MIL-E-63124A(AR)
AMENDMENT 3
10 May 1983
SUPERSEDING
AMENDMENT 2
7 September 1982

MILITARY SPECIFICATION

ELECTRONICS MODULE ASSEMBLY

FIGURE 1 Dispense signal

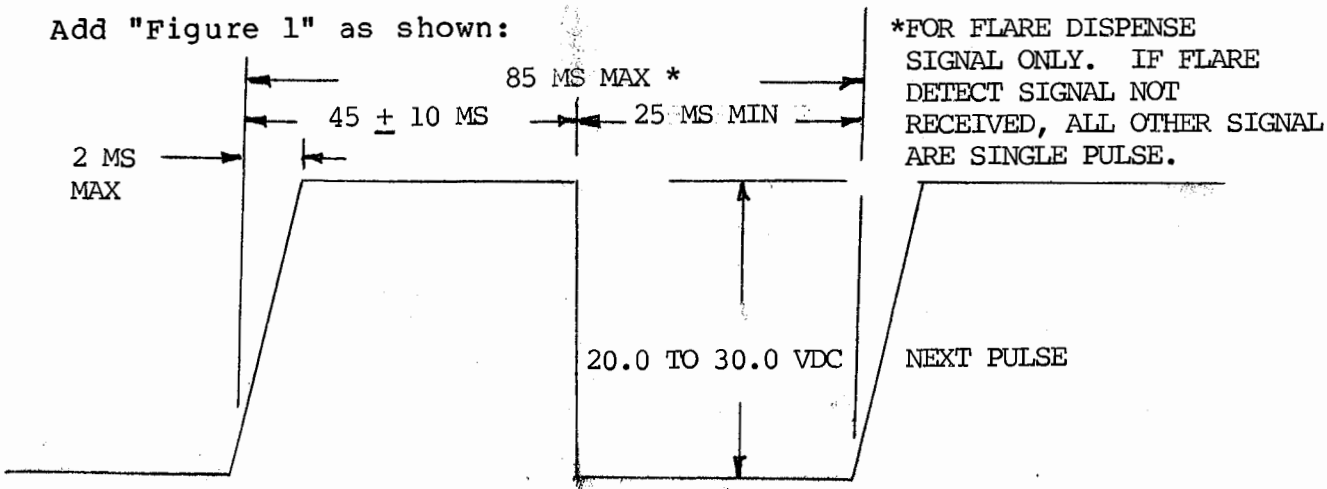
3.3.3, Change to read:

"The electronics module shall provide two outputs of 20.0 to 30.0 volts direct current (DC), a chaff dispense signal and a flare dispense signal, with characteristics conforming to Figure 1. These outputs shall be initiated by the respective input signals".

Add "Figure 1" as shown:

"A chaff count signal or a flare count signal shall be generated each time a chaff or flare is dispensed. Both count signals shall conform to Figure 1".
